[Docket No. FAA-2013-0724; Directorate Identifier 99-CE-013-AD; Amendment 39-17691; AD 99-26-19 R1]

Airworthiness Directives; Piper Aircraft, Inc. Airplanes

ACTION: Final rule.

Figure 1

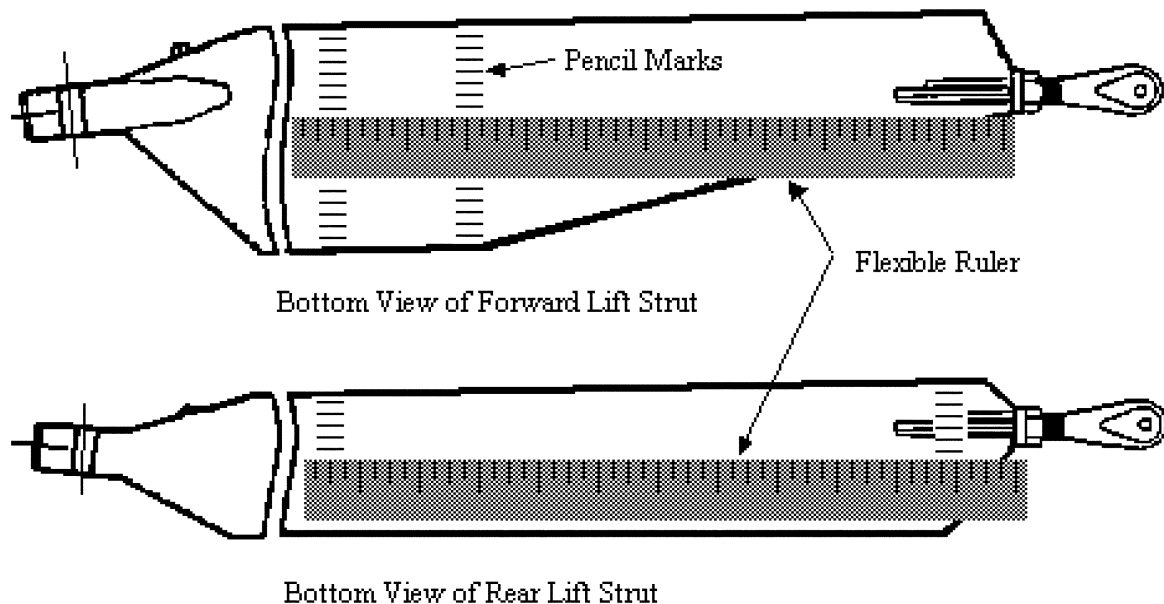
2. Using a flexible ruler, draw a $\frac{1}{4}$ -inch grid on the surface of the first 11 inches from the lower end of the strut as shown in Piper SB No. 528D, dated October 19, 1990, or Piper SB No. 910A, dated October 10, 1989. This can be done using a soft (#2) pencil and should be done on both faces of the strut. As an alternative to drawing a complete grid, make two rows of marks spaced every $\frac{1}{4}$ -inch across the width of the strut. One row of marks should be about 11 inches from the lower end of the strut, and the second row should be several inches away where the strut starts to narrow. Lay the flexible ruler between respective tick marks of the two rows and use tape or a rubber band to keep the ruler in place. See Figure 1.
